AIR RESERVOIRS: CHANGE OF THREADED RING OUTSIDE DIAMETER

WABCO air reservoir with new threaded ring (outside Ø 32 mm)

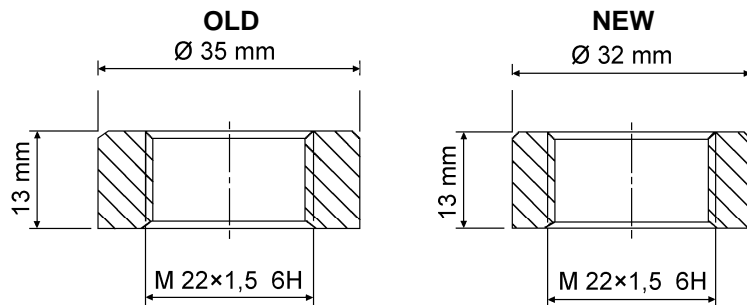
For reasons related to the harmonisation of production at WABCO's supplier, the outside diameter of the threaded ring for 30 air reservoirs will be changed from Ø 35 mm to Ø 32 mm.

- The change does not affect the functionality of air reservoir
- Inner threads M 22x1.5 mm are not changed
- The outside dimensions of threaded rings are not stated in WABCO drawings
- Declaration of conformity acc. EN 286-2 is available at our product catalogue [INFORM](http://inform.wabco-auto.com) (inform.wabco-auto.com) by entering the product number in the search field "Product Number" and clicking the radio button "Publication".
- The change will be implemented at the production line in August 2013
